**366-370 Albert Street | Materiality**

### APPLICATION TO AMEND A PLANNING PERMIT

<b>Application number:</b>	<b>TP-2019-835/B</b>
<b>Applicant / Owners / Architect:</b>	O'Neill Consulting / Sun Valley Construction Pty Ltd / Orchard Piper
<b>Address:</b>	364-370 Albert Street, EAST MELBOURNE
<b>Proposal:</b>	Amendments to the architectural plans to allow for partial demolition and reconstruction of the existing building.
<b>Cost of works of original permit application:</b>	\$29,000,000
<b>Date amendment received by City of Melbourne:</b>	6 September 2022
<b>Responsible officer:</b>	Xavier Livy, Principal Urban Planner

Figure 5: Basement pile wall location in respect to the retained walls of the service wing of 364 Albert Street. The basement pile locations intercept the retained wall resulting in piling close to and under the approved retained wall.

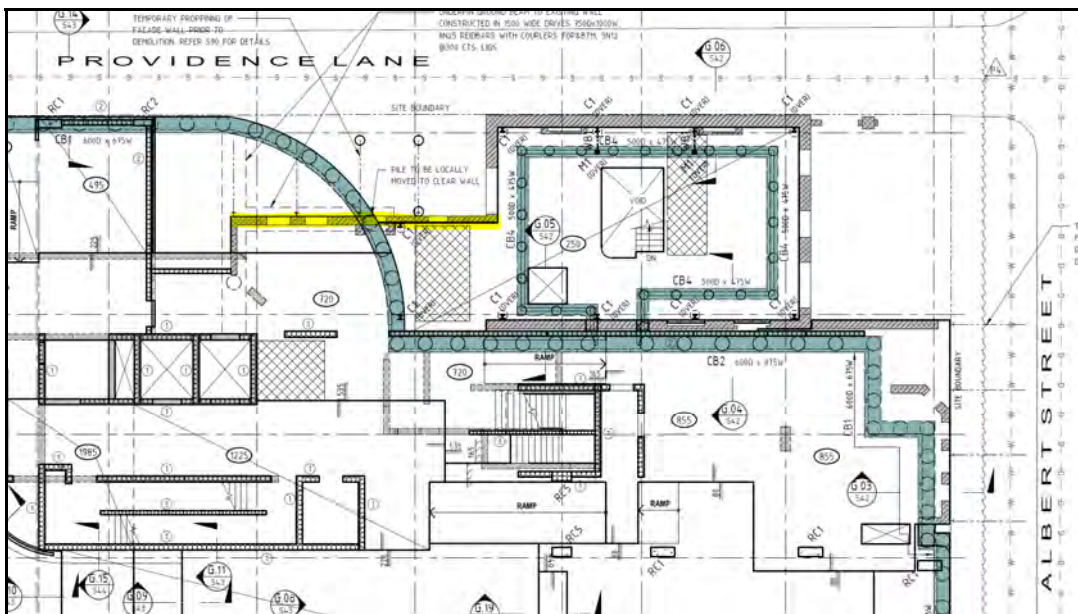
As the proposal progressed and upon receipt of more detailed structural engineering advice it became apparent that underpinning of the existing built form was not possible nor could construction works occur without introducing a high level of risk to the heritage fabric and general safety of users in the immediate area which has subsequently led to lodgement of this amendment application.

Figure 8: Walls highlighted in yellow to be demolished and reconstructed

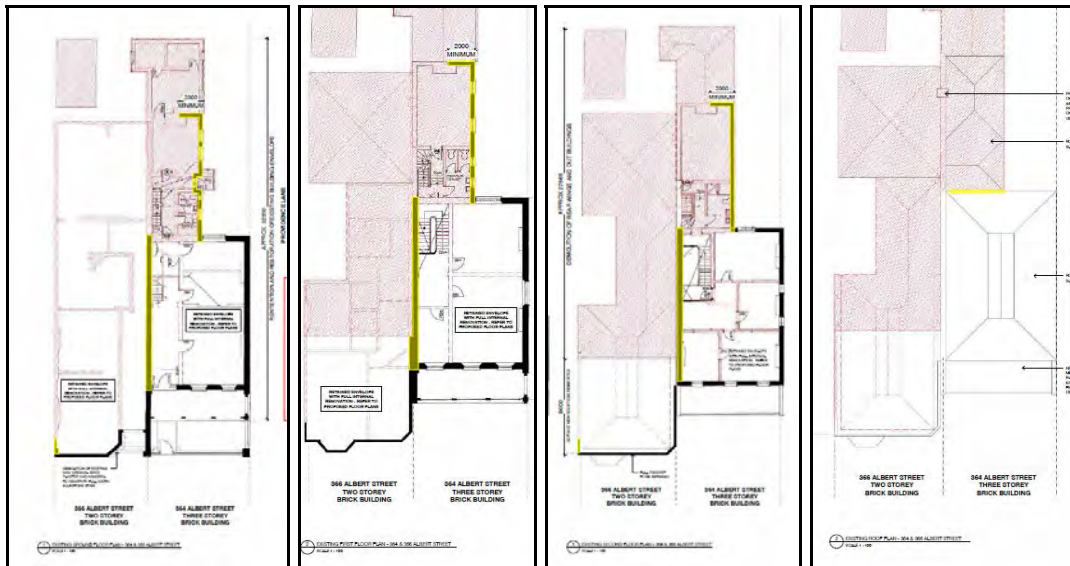
Notwithstanding, it was determined by the Tribunal in its interim order dated 15 October 2020 that the rear service wing was an important part of the building and its demolition could adversely impact the significance of the heritage place. Having regard to its significance it therefore follows that the rear service wing must remain and the key consideration as part of the application before Council relates to whether the temporary demolition and subsequent reconstruction is an acceptable planning outcome which is discussed further below.

3. A detailed written description of the deconstruction and reconstruction methodology is to be prepared by the Conservation Architect. It must be submitted to the Responsible Authority for approval prior to the commencement of any work to the affected heritage fabric. This Deconstruction and Reconstruction Management Plan should also describe the steps taken to ensure that no structural damage occurs to the retained existing significant building fabric as part of the deconstruction process and excavation works. Once endorsed, this methodology becomes part of this permit and must not be amended without first obtaining the written consent of the Responsible Authority.

Figure 9: Approved extent of demolition compared to proposed demolition

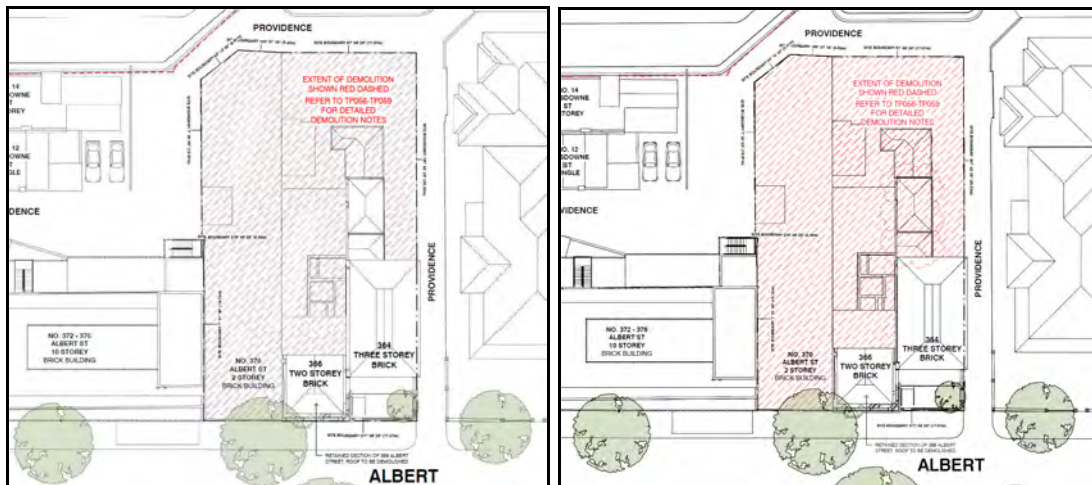
Having regard to the existing conditions and the nature of the work required to excavate and construct, the proposed basement presents risk to the heritage host and from a safety perspective. In this case the demolition of the rear wing while not strictly supported by planning policy, given the unique circumstances, the submitted technical reports and the advice from Council's Heritage Advisor, it is determined that in this instance the full demolition and replacement of the original fabric like for like is an acceptable and most appropriate course of action.

It is noted that in this instance the applicant is not gaining benefit from the proposed demolition. A Planning Permit has been issued at the direction of the Tribunal, which allows the proposed redevelopment including a four level basement and vehicle access from the eastern laneway. This application is a necessary step to ensure the broader heritage of the Site is protected and not impacted during construction works. Furthermore the Application does not result in any further developmental gain from what was approved under the existing approval for the Site. While demolition is proposed the reconstruction works will essentially result in a completed outcome consistent with existing approval for the Site. The applicant has provided sufficient information, through the assistance of a Heritage Conservation Architect, to satisfy that the additional demolition and reconstruction is not only achievable but acceptable and can be managed appropriately.
